## P9001A-02

# S E R V I C E N O T E

P9001A Agilent P9000 series Massively Parallel  
Parametric Test System

Industrial PC requires SATA digital cable and DVI extension cable to replace

SATA digital cable:

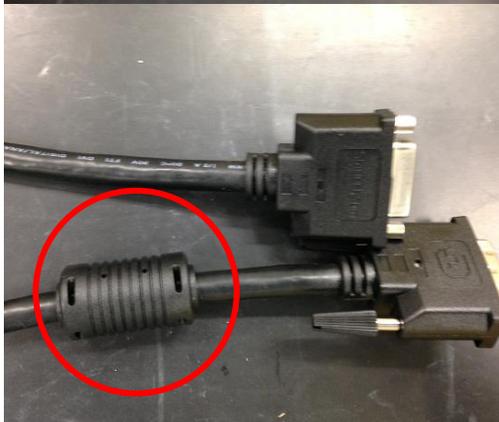
Old cable is longer (=1m)

New cable (PN 8121-2464) is shorter (=30cm)

Remove industrial PC from system cabinet, and replace PN 8121-2464 SATA digital cables (x 3ea) and PN 8121-2649 DVI extension cable.
